Electronic Pressure Relief Valve (EPRV) Delete & Fuel Rail Pressure Sensor Update

VOLVO

Model Years	Models
2018 - 2019	VAH, VHD, VN

Volvo Trucks has identified through Remote Diagnostics that the vehicles in this Service Campaign have experienced faults with the Electronic Pressure Relief Valve (EPRV). To address this issue follow the repair outlined within this bulletin to remove the EPRV, Update the Fuel Rail Pressure Sensor (FRPS) and wiring harness, followed by running an accessory kit to reprogram the vehicle.

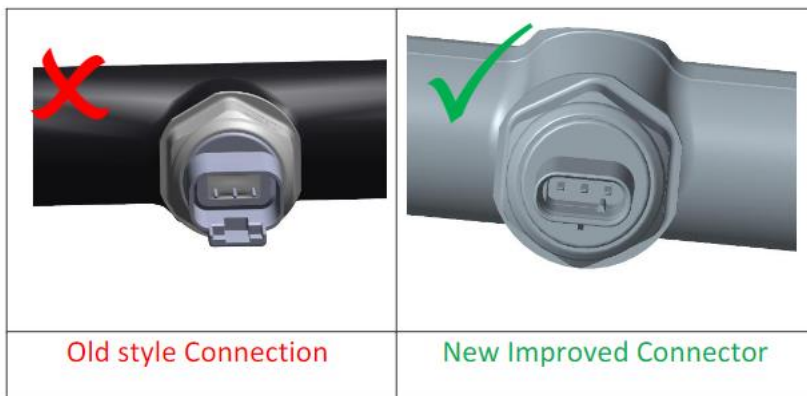
17. A product improvement has been made to the Fuel Pressure Sensor (FRPS) and its wiring harness. A visual inspection of the FRPS electrical connector will indicate which sensor and wiring harness is on the vehicle.

18. Inspect the FRPS, if the old-style connector is found (Displayed above with red X), replace the sensor and wiring harness per Impact Instructions listed below. If the new improved connector is found, no farther action is needed and proceed to next step.
 - a. 2373-03-03-06 Pressure Sensor, Common Rail, Replacement, Valve Cover Removed.
 - b. 2861-03-03-03 Wiring Harness, Injector, Replacement (Rear), Valve Cover Removed
19. Refer to IMPACT document ID: 2115-03-02-02 *Valve Cover, Replacement* for valve cover install procedure.
20. Using PTT Operation 1700-22-03-06 Program accessory kit: **85156014**
Note: Running this kit without removing the ePRV will result in adverse vehicle affects.
